ADDENDUM NO. 2

BID No. 09-0412

CONSTRUCTION OF RESTROOM FACILITY AT NORTH LAKE COMMUNITY PARK

1. Nystrom Louvers Manufacture Specifications

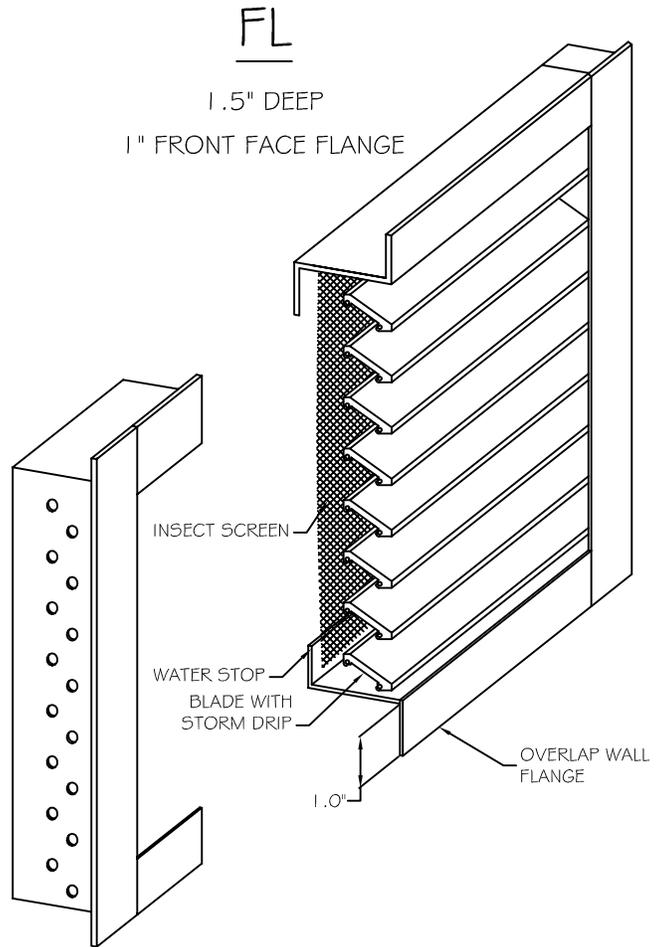
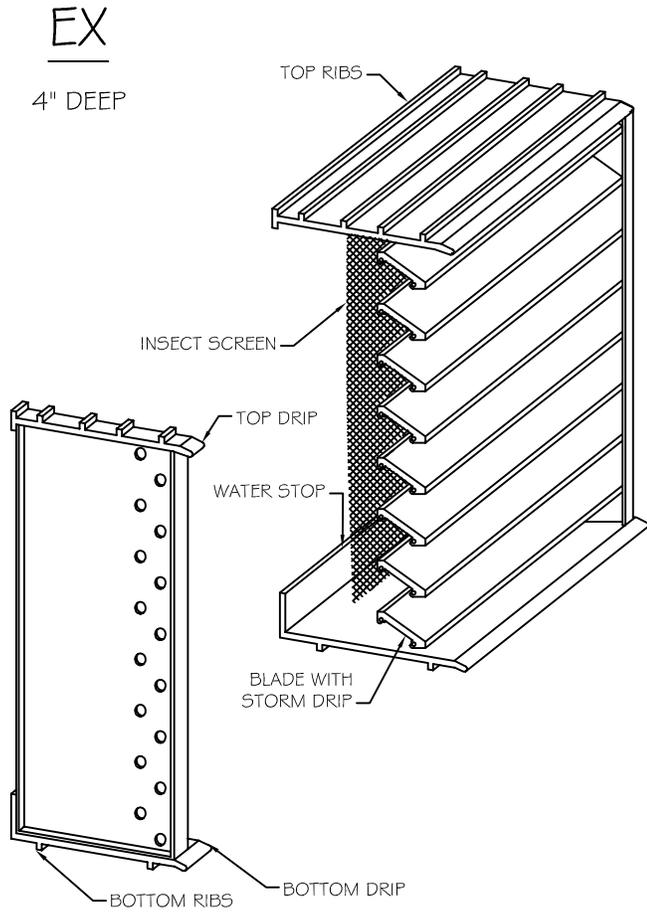
RFI Question 3: *There isn't a detail on how the wall louvers are to be installed or how they are to be fastened into place. Please provide a "cut" detail through a louver.*

RESPONSE: **Refer to detail 2 / A5.3.**

The wall louvers shall be installed per manufacturer's specifications. A manufacturer's (Nystrom Building Products, Inc.) cut sheet is being provided with this response for clarification. The upper and louvers shall be of model type "EX", installed via a mortared installation method.

Please note, all louvers shall be thoroughly caulked and sealed at the perimeter of the masonry opening. The louver shall be inclusive of an insect screen as noted on the drawings.
